Technical Service Bulletin: tsb100924

Released Date: 24-Feb-2010

New Intake Valve

Figure 1: New QSK19 Intake Valve

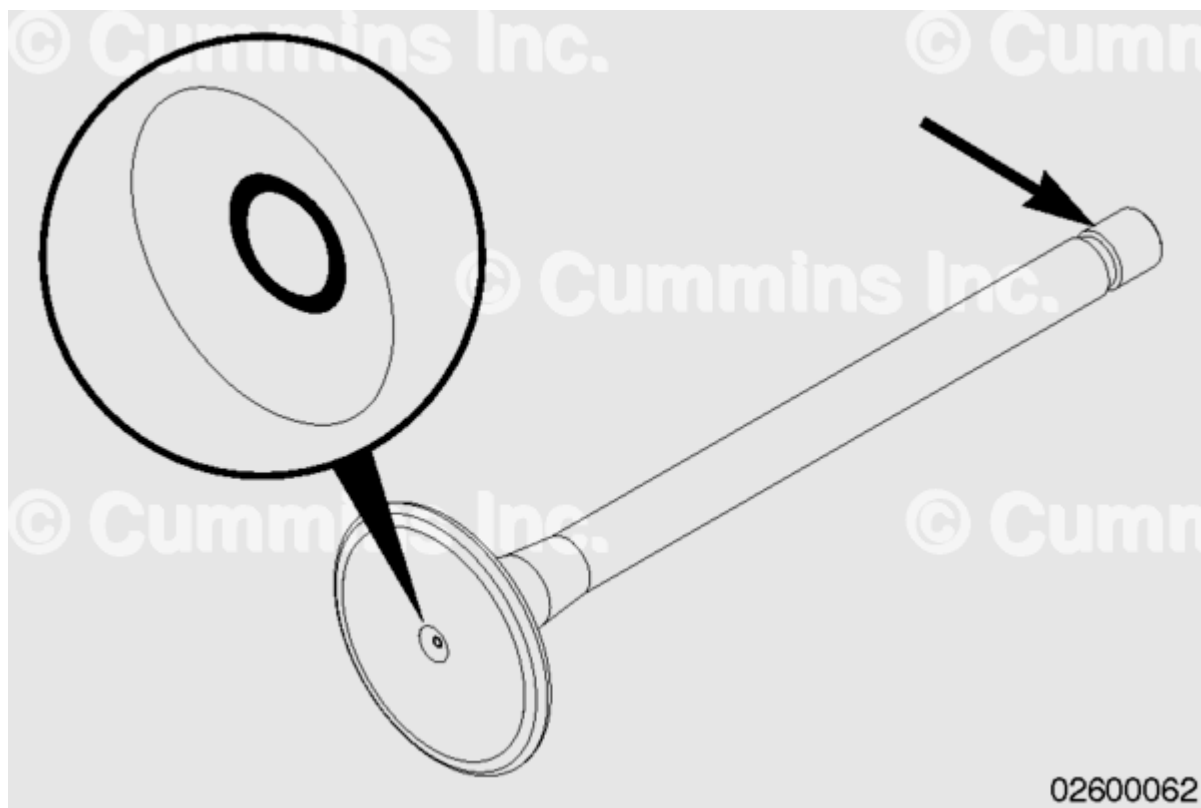
The new QSK19 MCRS Sursulf intake valve, Part Number 4986317, is a direct replacement for intake valve, Part Number 3052820.

The new valves have a darker appearance when compared to the old valves. The new valve can also be identified by the letter "O" forged onto the bottom center of the valve and by the part number laser-etched into the stem, above the collet groove. See Figure 1.

The new intake valve is **only** available as a kit, with two new collets, Part Number 2881836.
